# Task Force Princess Elisabeth Zone

16<sup>th</sup> of May 2024

## Public consultation Task Force Princess Elisabeth Zone

# Forecasting of OBZ prices and congestion forecast

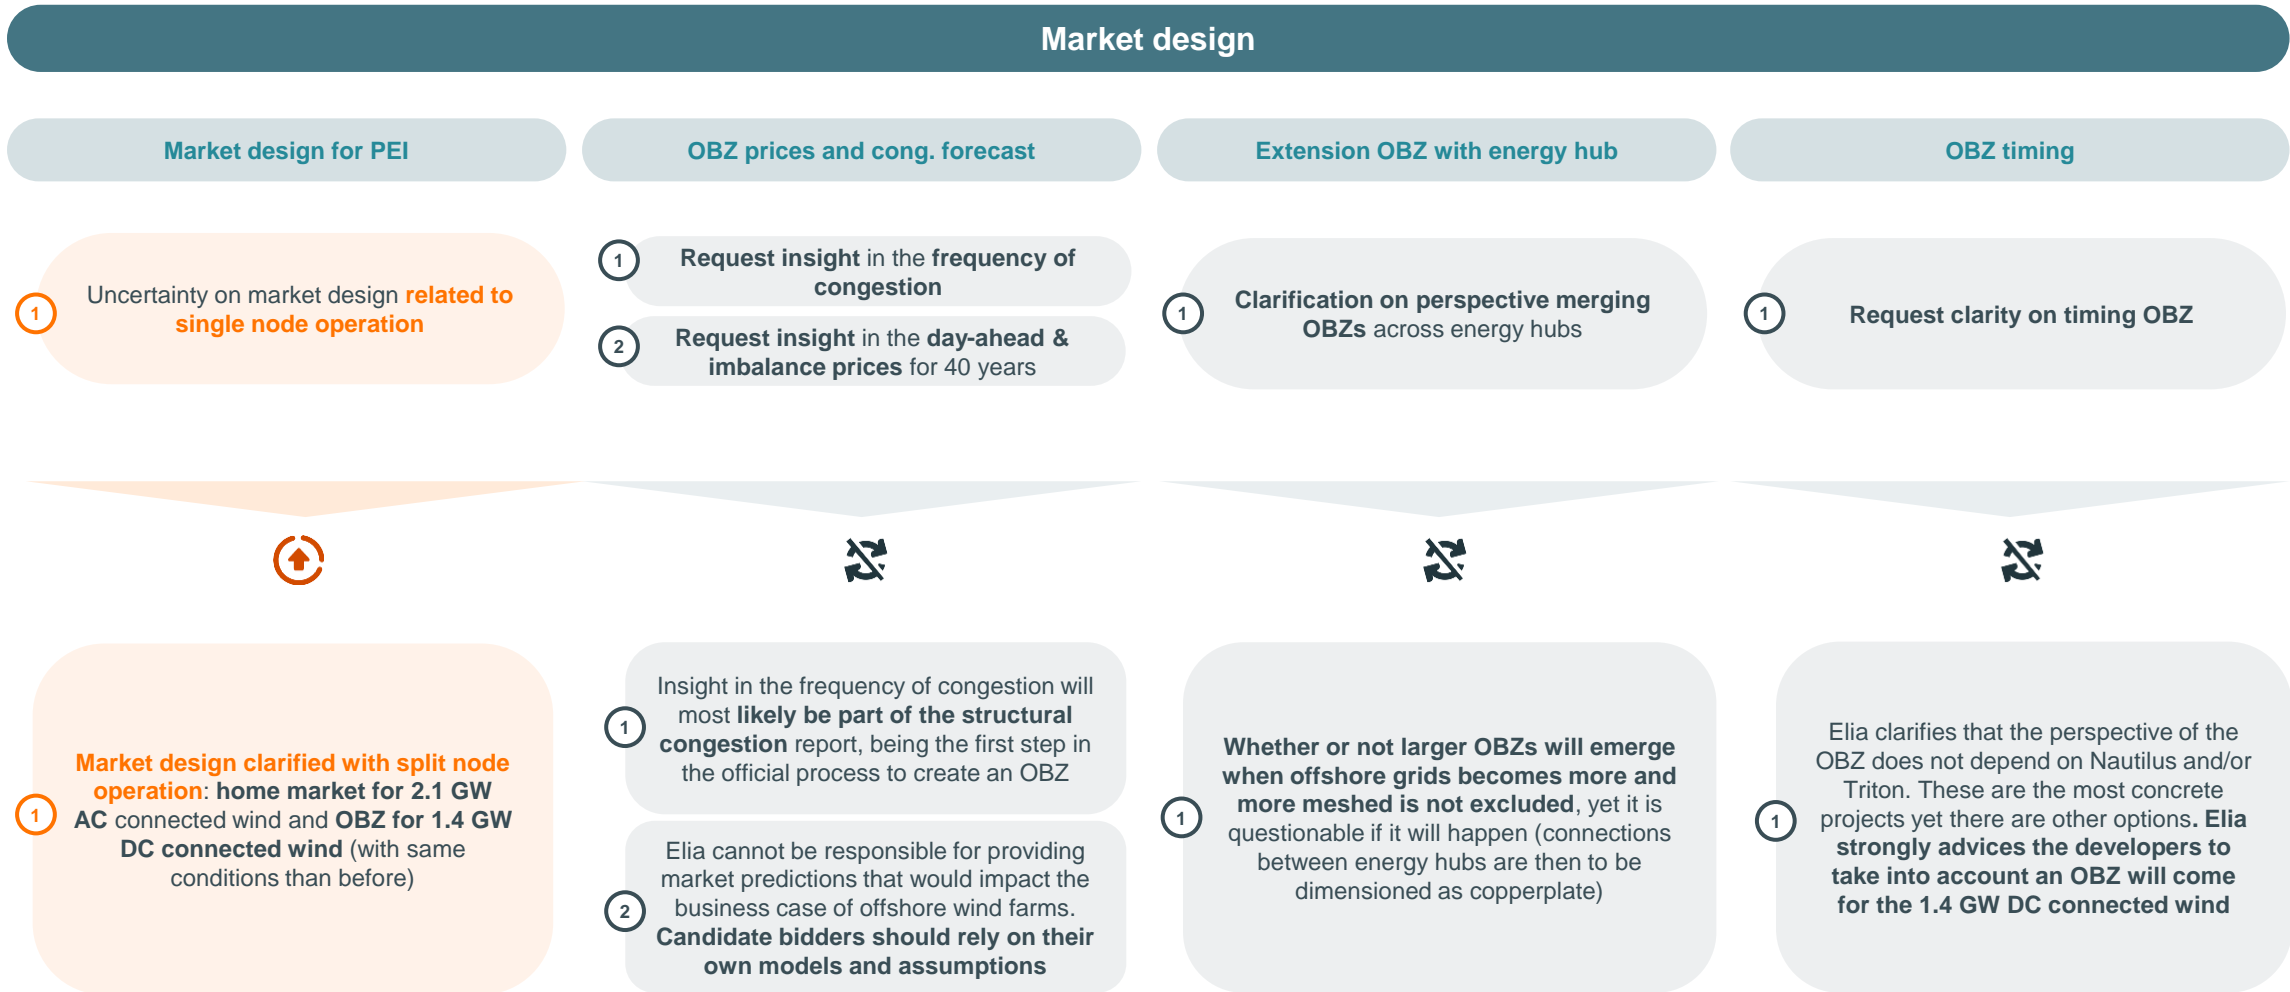
Market parties requested insight in

- 1 the **frequency of congestion** in the day-ahead
- 2 the **imbalance prices** over the coming 40 years

- 1 Insight in the frequency of congestion will **most likely be part of the structural congestion report**, being the first step in the official process to create an OBZ
- 2 Elia cannot be responsible for providing market predictions that would impact the business case of offshore wind farms. **Candidate bidders should rely on their own models and assumptions.** Therefore Elia has not assessed the accuracy of predicting wholesale or imbalance prices in an offshore bidding zone context

# High Wind Speed (HWS) technology requirements

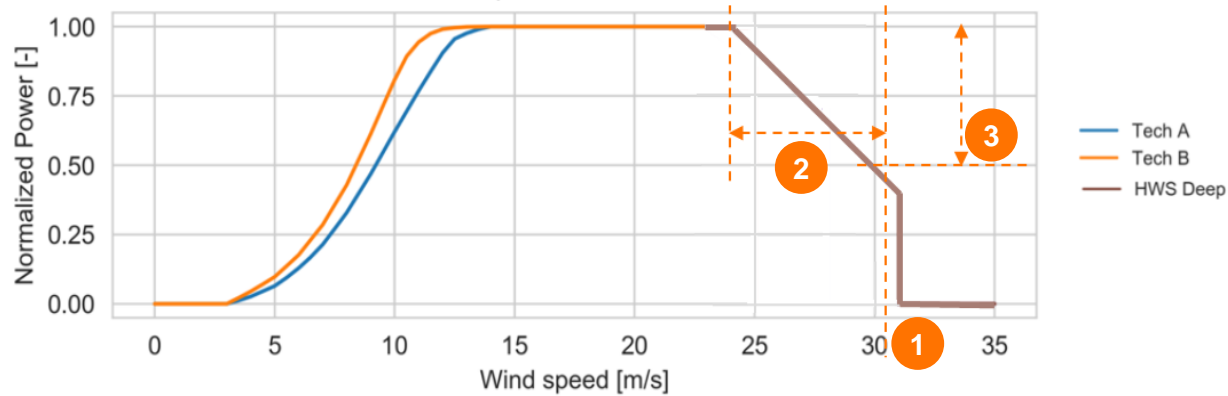
Some stakeholders raise concerns about the possibility that some manufacturers would not comply with this requirement and ask to keep the requirements as open / soft as possible

Some stakeholders request to clarify the requirements for wind gusts and average wind speed variations within the 10' average wind speed period

- Towards and during the consultation, **no reactions were received from the manufacturers** indicating that the requested capabilities would be infeasible.
- Bilateral discussions with some manufacturers, and Technical University of Denmark in 2022 and 2023 indicated that **HWS capabilities would become standard technology**
- **Analysis** of the technical specifications received from latest Belgian offshore parks (2020) show that these **can already maintain 31 m/sec** (and a part even for the 10' average time)

Elia will clarify this in the connection requirements and refers to the table on page 14 of the original MOG 2 study. It will clarify in the report that it will only allow disconnection if wind speeds exceed a 34 m/sec average over 30 seconds and 38 m/sec average over 1 second according to the HWS Deep profile put forward.

*While the 10' average time of 31 m/sec will be specified as hard requirements, Elia will formulate the 30" and 1" requirements as soft requirements, allowing to specify lower values when justified by the technical specifications given by the manufacturer*

# Improvement of the trigger design

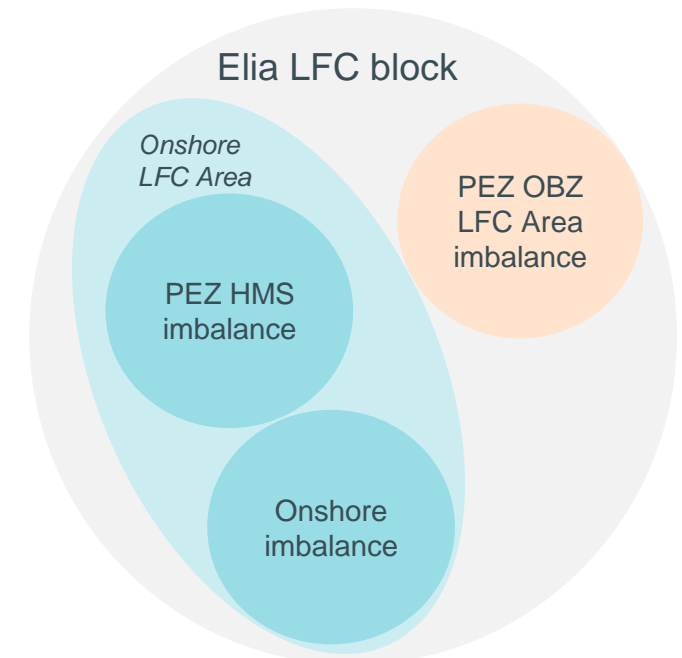
Market parties highlight that a trigger based on the LFC block imbalance, onshore excess imbalances can cause situations where 'balanced' PEZ wind parks are impacted by the Ramp Rate Limitations. Such situations may reduce excess generation in their portfolio and even expose these wind parks to shortages.

- **Elia recognizes the possibility of triggering the measure following onshore excess imbalances**, even when the offshore wind parks are not contributing to the imbalance.

- This undesirable situation is the counter-side of accounting netting between the onshore and offshore areas within the LFC block. This intends to minimize activations of the measure during onshore shortages.

# Clarification on the application of the preventive cap with split node operation

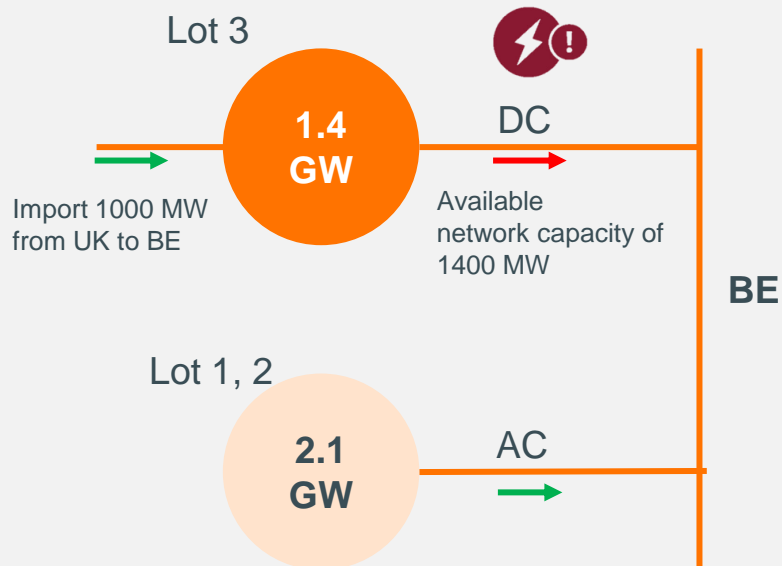
Market parties highlight the uncertainty of a single-node versus split-node operation on the implementation of the preventive cap and ask for clarity on the application of the preventive cap for the lot 1, 2 and 3 wind parks.
